Stormwater Drainage Report comments - Copy.pdf Markup Summary

Bret Dilts - DPW Engineering (3)

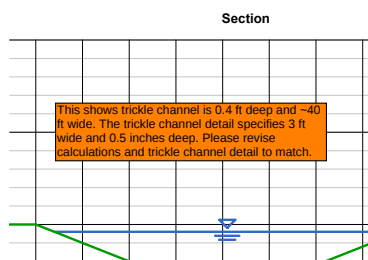
Note: Per DCMv2 – Chap 4.2, trickle channel should at a minimum provide capacity equal to twice the release capacity at the upstream forebay outlet(s).

8.19 cfs satisfies this requirement, just wanted to clarify what was needed.

This shows trickle channel is 0.4 ft deep and ~40 ft wide. The trickle channel detail specifies 3 ft wide and 0.5 inches deep. Please revise calculations and trickle channel detail to match.

TAIT Response:
The trickle channels have been sized to convey 2 x the upstream forebay discharge rates.

TAIT Response:
The trickle channels have been sized to convey 2 x the upstream forebay discharge rates. Updated channel calculations are included in the report.
